Mercedes-Benz

Campaign No. 2019100008, November 2019

SUBJECT: **Model 907 (Sprinter), Model Year 2019**
Replace Side Window

D67.30-A001-79

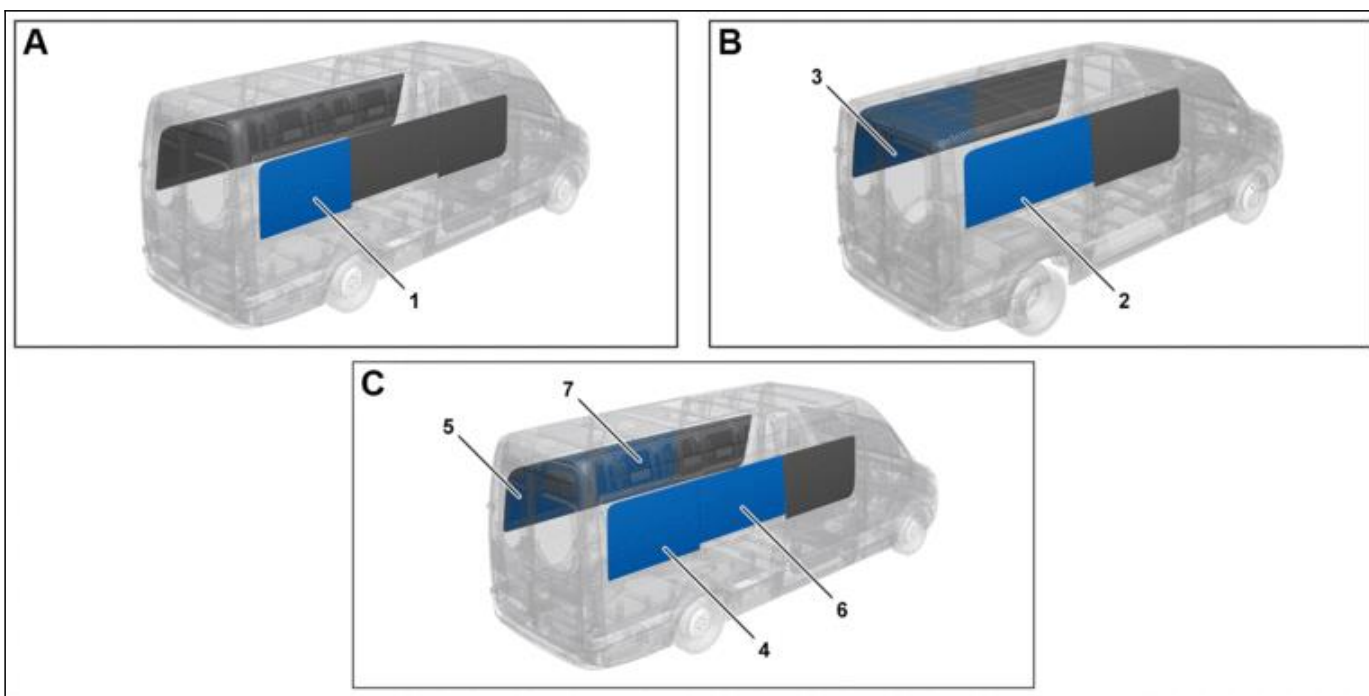
2.1	Replace rear right side window (1).	<p>Model 907.745 1P as of 021618 up to 100312 with code F43 (Side windows in rear laminated glass)</p> <p>Model 907.745 1T as of 000156 up to 005399 with code F43 (Side windows in rear laminated glass)</p> <p>i</p> <p>See picture A</p> <p>i</p> <p>Dispose of removed side window (1) properly. Observe the applicable legal requirements and specifications of the relevant country.</p>	AR67.30-D-2400TS

2.2	Replace side windows (2, 3) at rear left and right.	<p>Model 907.643 1P as of 049635 up to 124633 with code F43 (Side windows in rear laminated glass)</p> <p>i</p> <p>See picture B</p> <p>i</p> <p>Dispose of removed side windows (2, 3) properly. Observe the applicable legal requirements and specifications of the relevant country.</p>	AR67.30-D-2400TS

2.3	Replace left center, right center, rear left and rear right side windows (4, 5, 6, 7).	<p>Model 907.645 1P as of 058365 up to 107867 with code F43 (Side windows in rear laminated glass)</p> <p>Model 907.647 1P as of 103982 up to 120724 with code F43 (Side windows in rear laminated glass)</p> <p>Model 907.655 1P as of 054351 up to 124991 with code F43 (Side windows in rear laminated glass)</p> <p>Model 907.657 1P as of 073138 up to 125930 with code F43 (Side windows in rear laminated glass)</p> <p>i See picture C</p> <p>i Dispose of removed side windows (4, 5, 6, 7) properly. Observe the applicable legal requirements and specifications of the relevant country.</p>	AR67.30-D-2400TS
-----	--	--	------------------
